Bryant Homes
Technical Services Ltd

title
BALMORAL
CENTENARY
F. FLOOR CARCASSING PLANS & DETAILS

drg no BO C 40 E

# JOIST DETAIL SHOWING PERMISSIBLE NOTCHING AND HOLES
SCALE 1 : 5

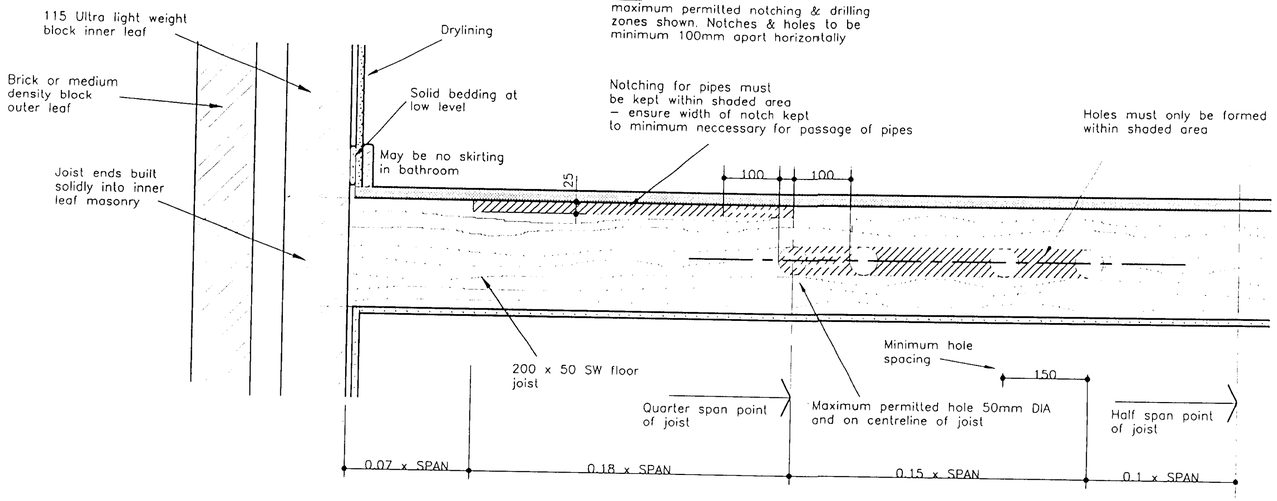
Rev B _ Notches/holes to be min 100 apart.
03/05/95

FIRST FLOOR CARCASSING PLAN

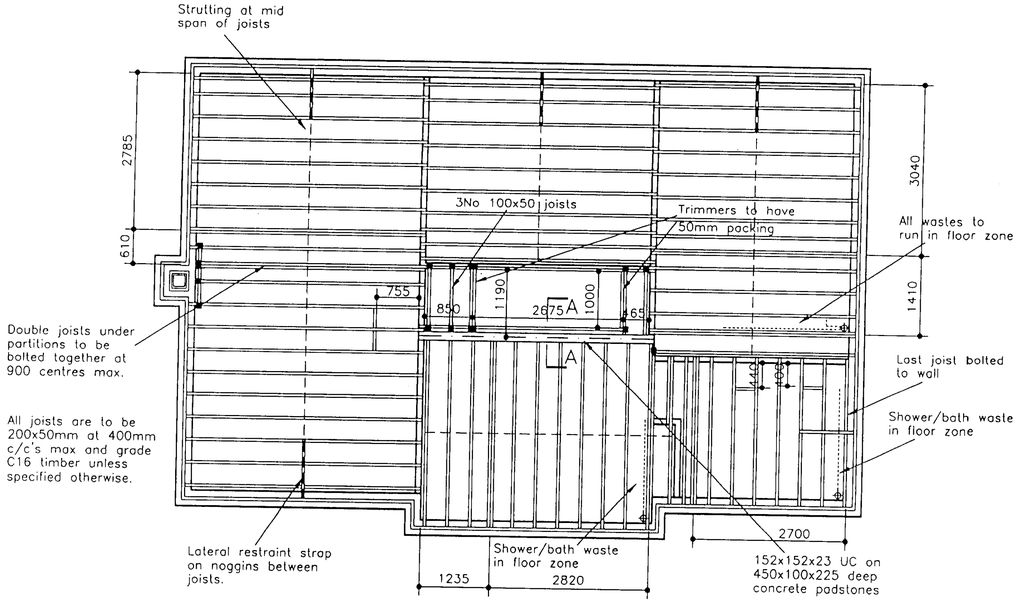
Rev A _ 200x75 joist omitted. 50mm packing added to trimmers. Joist hangers indicated.
19/05/94

Rev C _ Packing soldiers noted behind each joist hanger to UC. Strutting omitted over Study. Trimming to flue revised.
03.04.96

Rev. D _ Joists re-spaced at 400mm c/c from 450mm c/c. Timber grade added.
10.10.97

E: Detail A revised & floor carcassing plan updated to reflect revised floor plan. Front gable enlarged
13:05:99
